VAR-20524

AMENDED TENTATIVE MAP
WINDERMERE @
PROVIDENCE / CLIFFS EDGE

**RE: Cliff's Edge Master Plan Community
Preliminary Project Plan Submittal – POD 211 – Windimere Unit 2
Plan Date: NA**

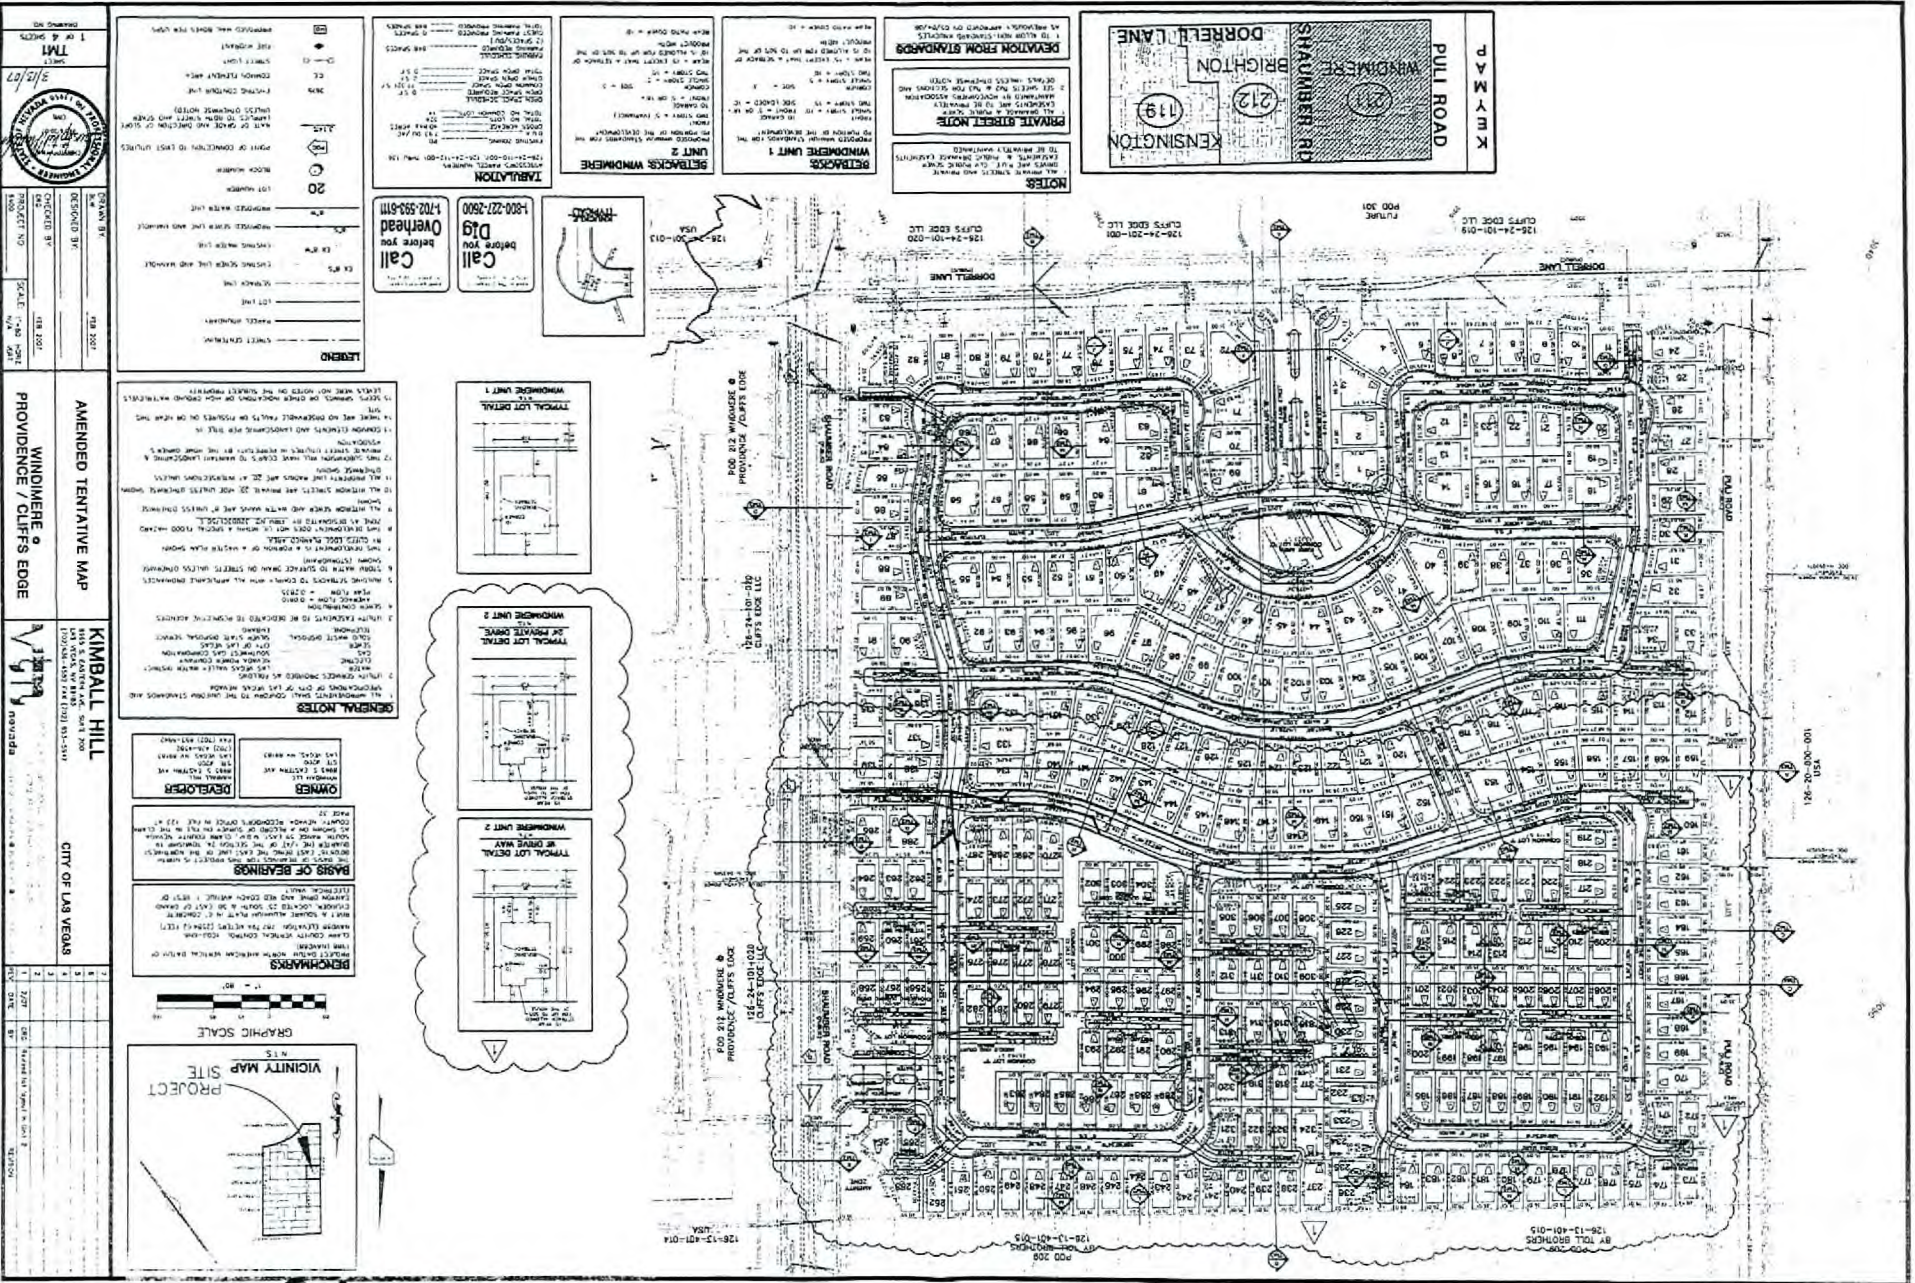
- ◆ Floor plan modifications, if any, per style should be indicated.
- ◆ Complete wrap elevations for each style should be submitted.
- ◆ Corner side enhancement should be shown.
- ◆ Visible rear and side elevations should be shown.
- ◆ Roof plans should be provided.
- ◆ Amended Tentative Map received March 8, 2007, does not show typical lot detail adjacent to curvilinear roads.
- ◆ Building footprint and detail for all lots should be submitted.
- ◆ Preliminary design for entry landscape should be submitted.

Based on the above noted comments, we recommend "**Approval with Conditions**" of this Preliminary Project Plan submittal. (*)Although the requested front setback does not meet the standard requirements, it does provide for a front aesthetic that eliminates the typical garage forward design that we wish to avoid. In addition, driveway depths of 5' and 18', which are the preferable depths by both the master developer and the City of Las Vegas must be met. With these characteristics in mind, DRC recommends approval of the Site Plan as requested.
